World Forum for Harmonization of Vehicle Regulations**Working Party on General Safety Provisions****104th session**

Geneva, 15–19 April 2013

Regulation No. 107 (M₂ and M₃ vehicles):**Proposal for further amendments****Proposal for the 06 series of amendments to Regulation
No. 107 (M₂ and M₃ vehicles)****Submitted by the experts from the European Commission, France and
Germany ***

Model A

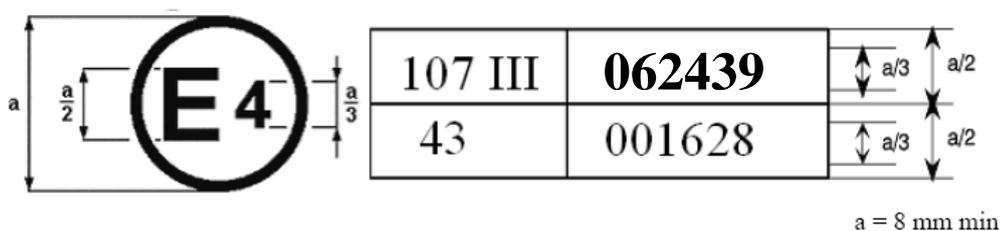
Annex 2, amend to read:

The above approval mark under approval number **062439**. The approval numberas amended by the **06** series of amendments.

"Figure 23

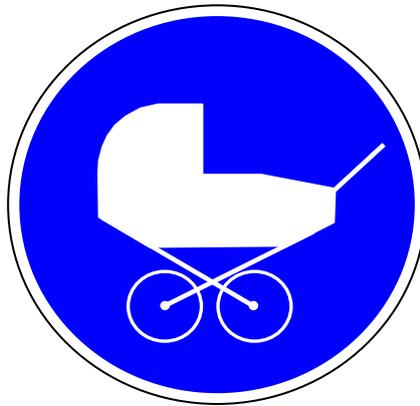
Figure 23, amend to read:
